NPL 2000-0271

DOCKETS 50-266 AND 50-301
SUPPLEMENT 3 TO APPLICATION FOR AMENDMENT TO
FACILITY OPERATING LICENSE APPENDIX A:
TECHNICAL SPECIFICATIONS IMPROVEMENT PROJECT
RESPONSE TO RAI ON ITS SECTION 3.6
POINT BEACH NUCLEAR PLANT, UNITS 1 AND 2

DOCKETS 50-266 AND 50-301
RESPONSE TO REQUEST FOR ADDITIONAL INFORMATION
TECHNICAL SPECIFICATIONS IMPROVEMENT PROJECT SECTION 3.6
POINT BEACH NUCLEAR PLANT UNITS 1 AND 2

RAI 3.6.3-11

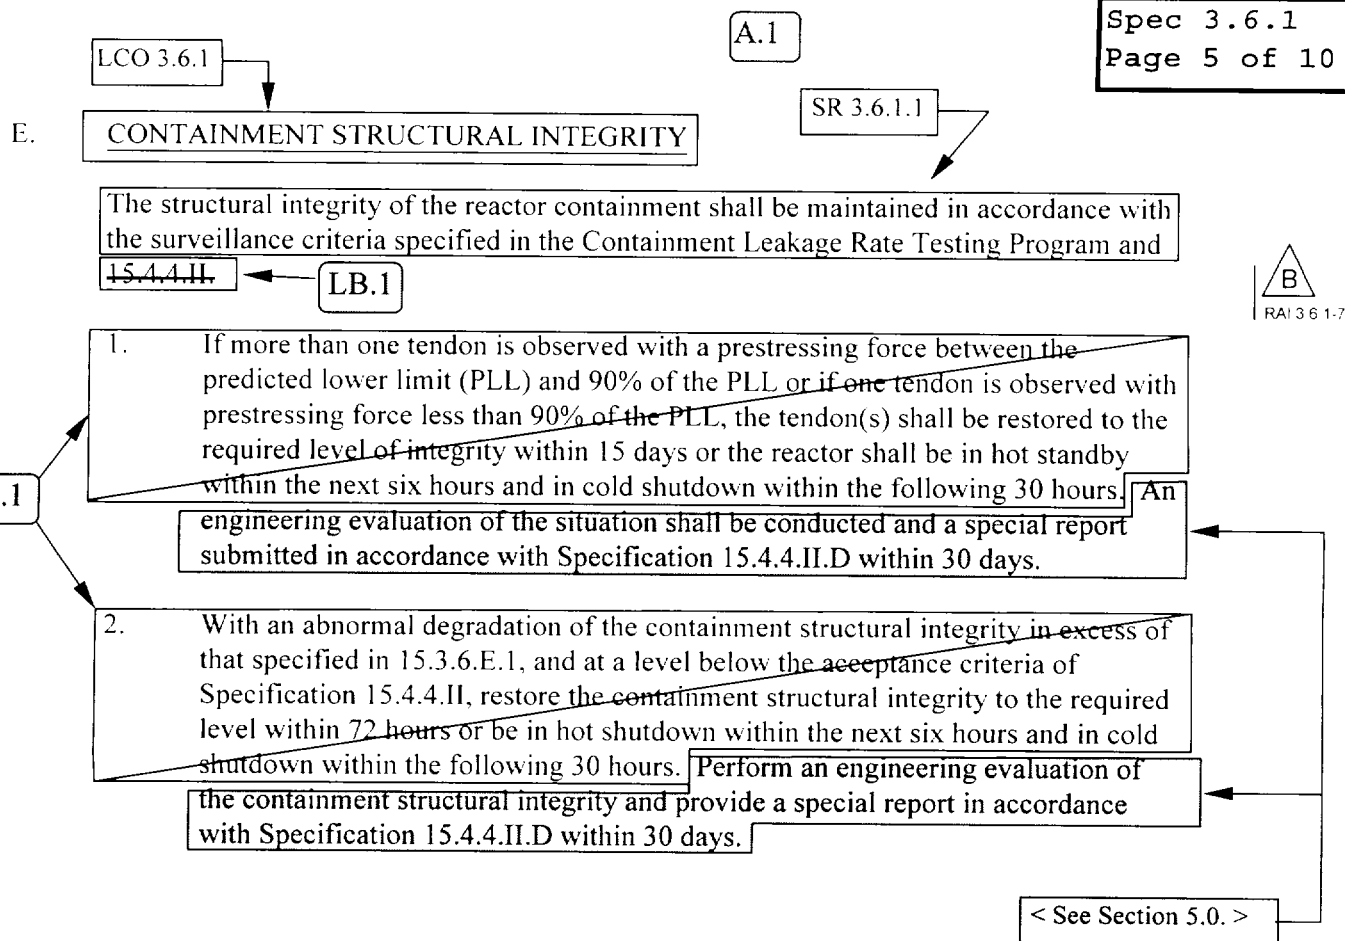
CTS 3.6.A.1.c.(2) states that if containment purge penetration leakage results in exceeding the overall containment leakage rate acceptance criteria, one enters CTS 3.6.A.1.a. The CTS markup of 3.6.A.1.c.(2) shows this requirement as part of ITS 3.6.1. This is incorrect. This CTS requirement in this case is ITS 3.6.3 ACTION Note 4 with regards to purge valves. Thus the change is an Administrative change.

Comment: Revise the CTS markup and provide the necessary discussion and justification for this Administrative change.

RAI 3.6.7-6

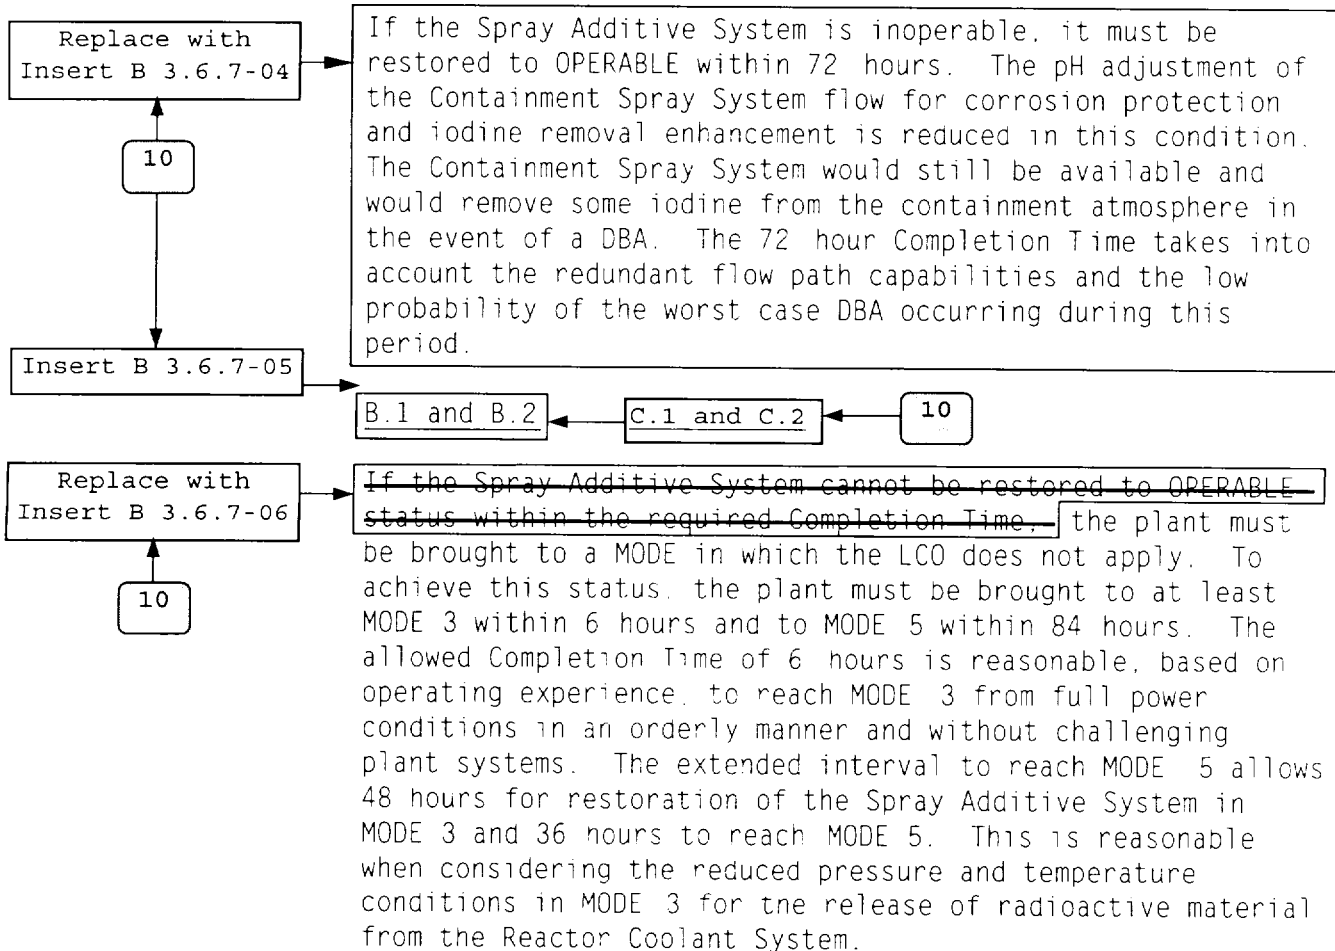
ITS 3.6.7 ACTION A is added to the CTS markup of CTS 3.3.B.2.c. This addition is justified by DOC L.1. The Staff agrees that the addition of ITS 3.6.7 ACTION A is a Less Restrictive (L) change, however DOC L.1 does not provide sufficient discussion and justification for this change. The following CTS items have not been addressed by the addition of ACTION A:

Comment: Revise the CTS markup to address item 1 above and provide additional discussion and justification for this Less Restrictive (L) change.

ITS 3.6.7 has been modified to more closely reflect the requirements of CTS 15.3.3.B. Condition A will allow 72 hours to restore an inoperable Spray Additive System flowpath. Condition B applies to all other system inoperabilities and allows 1 hour to restore at least one flowpath to an operable status. If the Required Action and Completion Time of Condition A or B are not met, Condition C requires the unit to be in MODE 3 in 6 hours and MODE 5 in 84 hours. The additional time to reach MODE 5 is justified in DOC L.2. Additionally, statements in DOC L.1 and JFDs 5 and 7 have been modified to reflect current licensing basis for the addition of NaOH to containment spray, to aid in the absorption of iodine from the containment atmosphere. The changes made to ITS SR 3.6.7.2, per JFD 8, have been removed to enable the insertion of a spray additive tank volume requirement, consistent with CTS 15.3.3.B.1.a. Lastly, JFDs 1 and 3 were modified to clarify a subjective statement and an imprecise statement that could potentially be misinterpreted.
